PCN# 20240806004.1

**Qualification of RFAB using qualified Process Technology, Die Revision, and additional Assembly BOM options for select devices
Change Notification / Sample Request**

Date: August 06, 2024

Sample product shipping label (not actual product label):

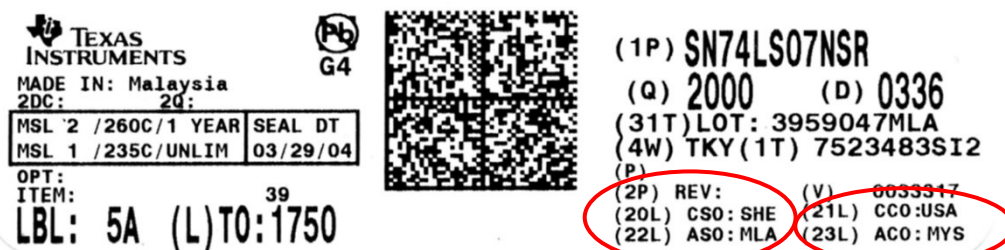
Changes to product identification resulting from this PCN:**Fab Site Information:**

Chip Site	Chip Site Origin Code (20L)	Chip Site Country Code (21L)	Chip Site City
SH-BIP-1	SHE	USA	Sherman
RFAB	RFB	USA	Richardson

Die Rev:**Current****New**

Die Rev [2P]	Die Rev [2P]
D	A
